**SB-10056246-2845**

Bulletin No.: P1281

## Service Bulletin

**Subject:** Sliding Door Does Not Stay Open While Vehicle is on a Downslope and/or Sliding Door Closes too Easily

3955182

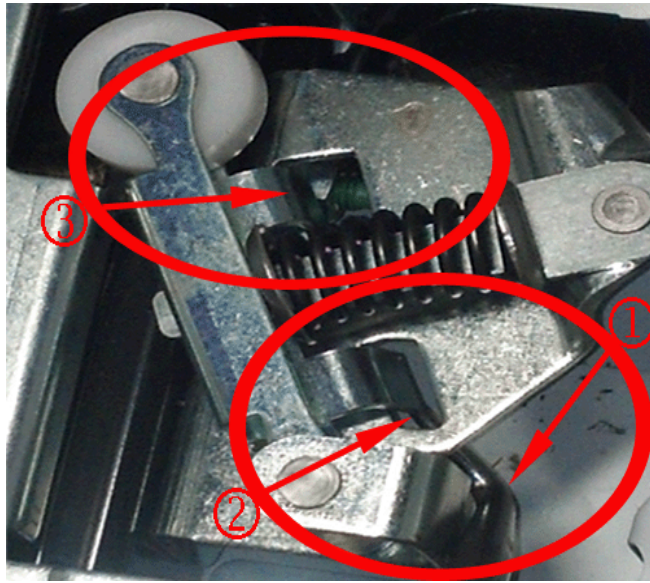
Some customers may comment that the sliding door does not stay open while the vehicle is on a downslope and/or sliding door closes too easily.

This condition may be due to the position of the roller arm not holding the sliding door in the open position.

Reposition the roller arm further outboard, to create a better hold on the sliding door while open, following the steps listed below:

3955189

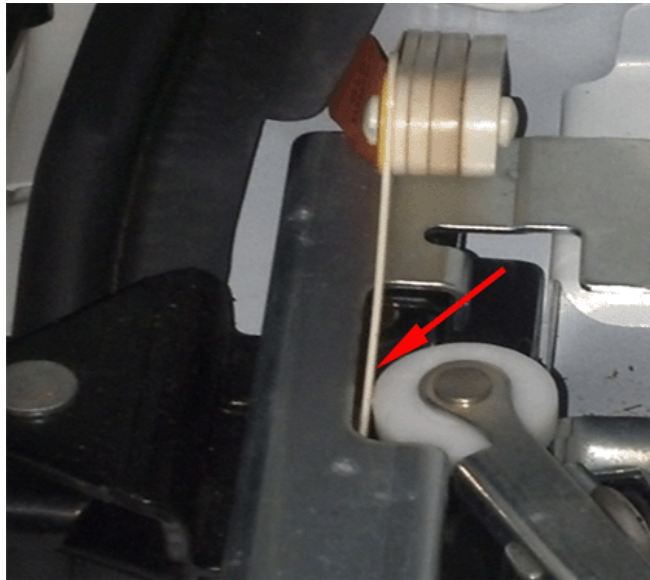
2. Use a pick tool and place under the base plate of the checker (1) and hook the tab (2) while bending inboard. Ensure the tab that is closest to the roller is now touching the trim edge (3) of the window with no gap as shown in the illustrations above.

3. Measure the gap from the outboard edge of the roller to the track. Ensure a 1.25 mm (0.05 in) maximum gap.
